J2023-0002  
PSP2023-0014  
Revision #4  
Received 9/20/2023

**Site Plan Review**

**EAST HAMLIN ROAD STORAGE**

**PRELIMINARY SITE PLAN**  
**1575 E HAMLIN RD**  
 PART OF THE SE 1/4 OF SECTION 24, T3N, R11E  
 ROCHESTER HILLS, OAKLAND COUNTY, MICHIGAN

sheet title:  
**LANDSCAPE PLAN**

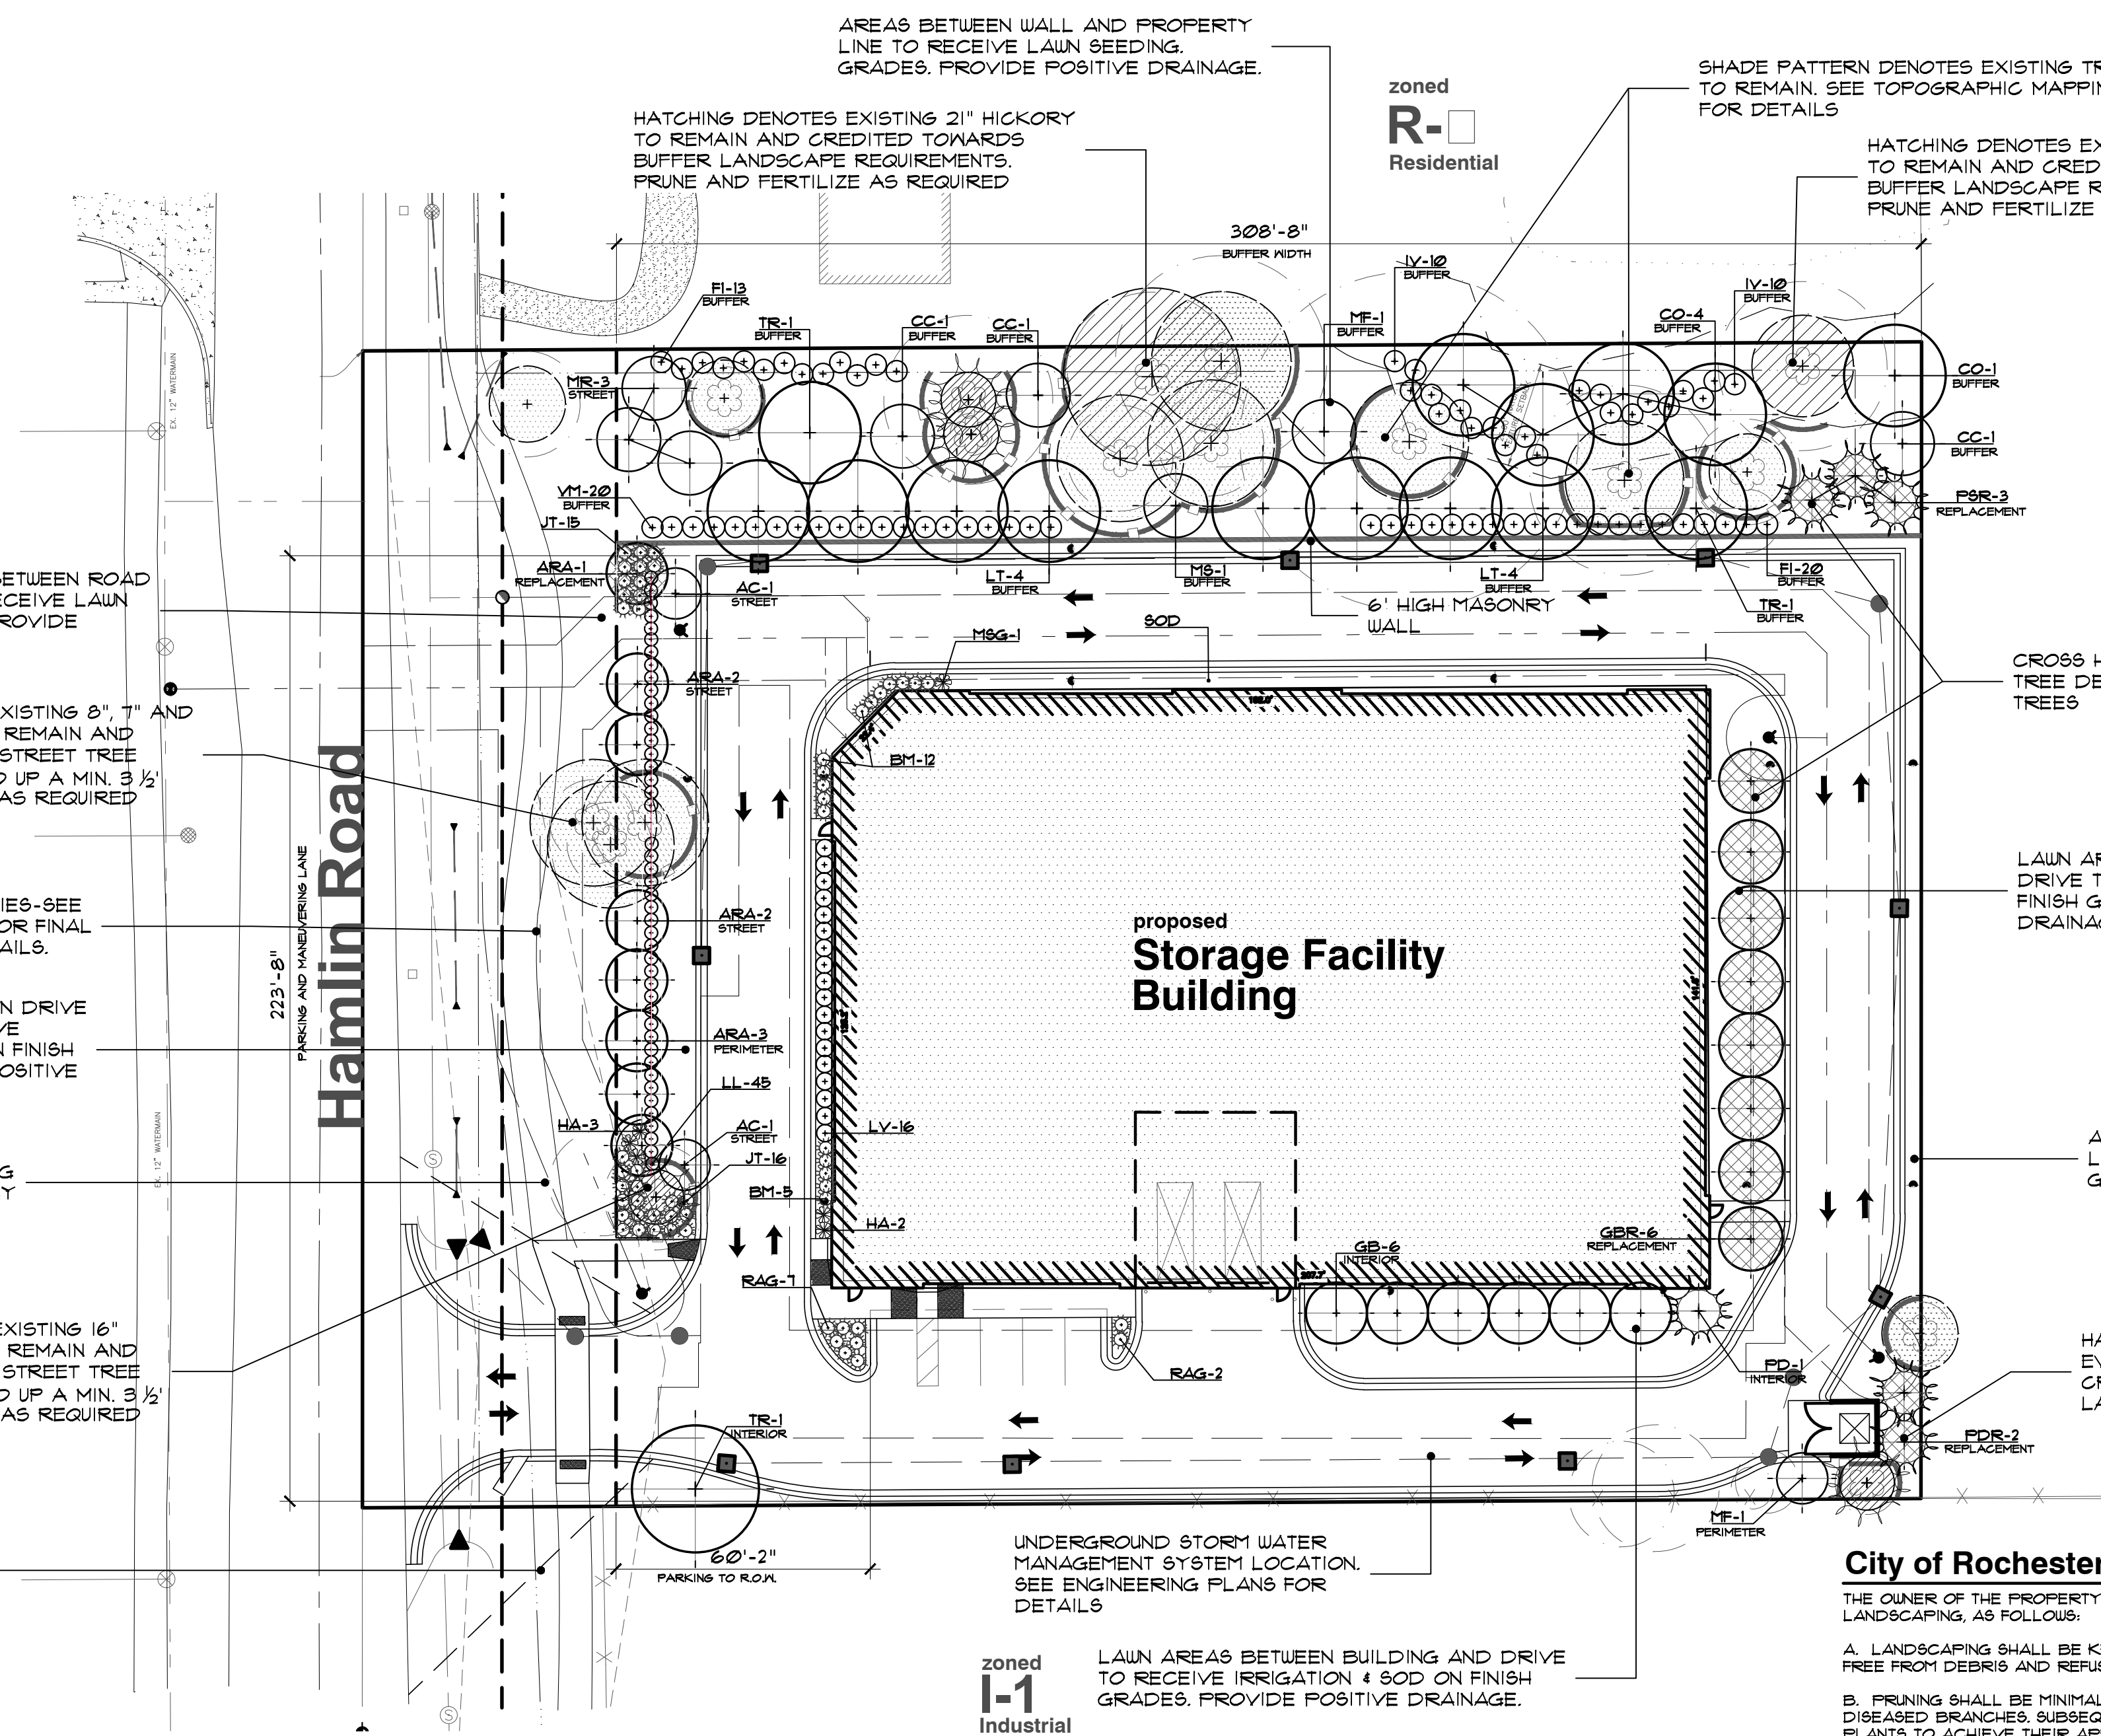
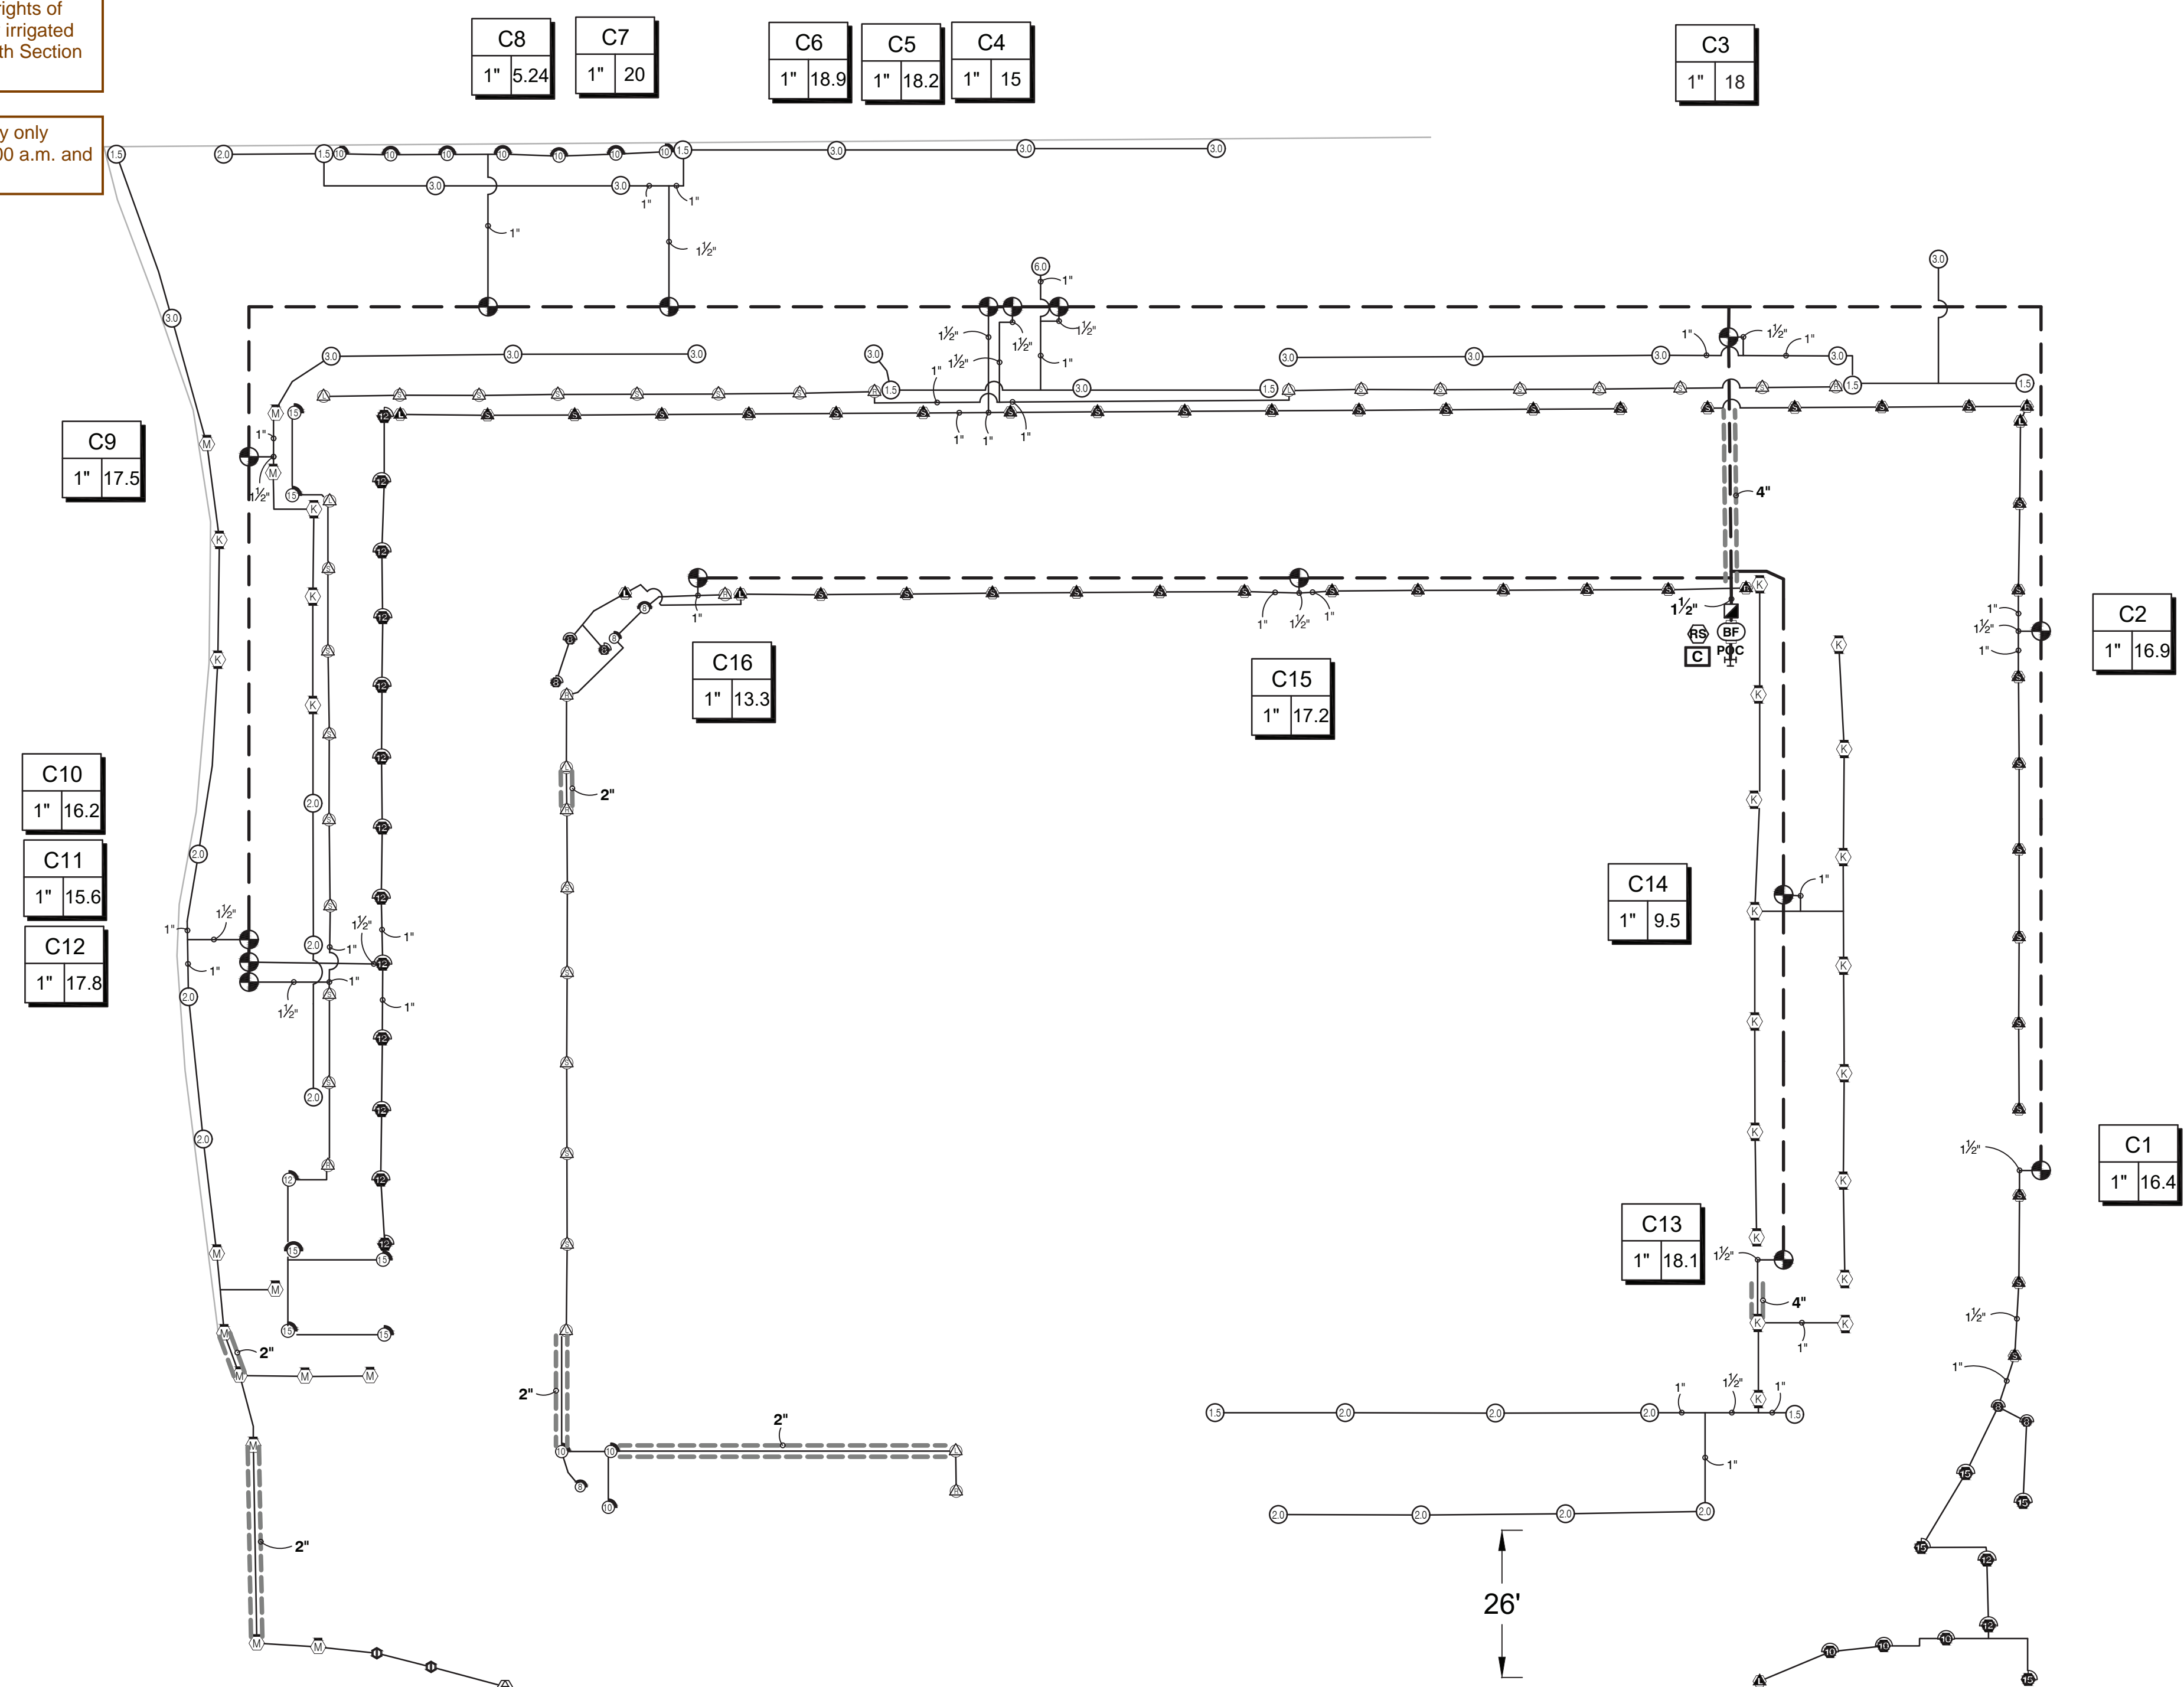
Any plant material that is designated to be maintained that dies or is damaged during or as a result of construction shall be replaced pursuant to City Ordinance.

Drawing Title:  
IRRIGATION DESIGN

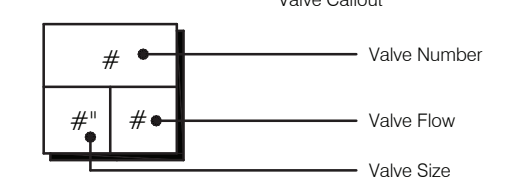
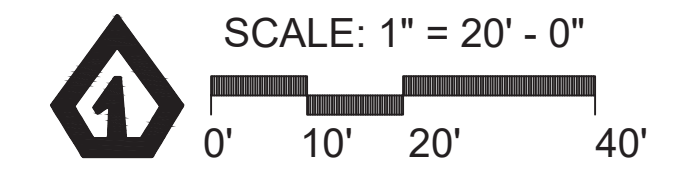
All landscape and grass areas, including rights of way shall be fully irrigated and compliant with Section 138-12.105.

Site irrigation may only occur during 12:00 a.m. and 5:00 a.m.
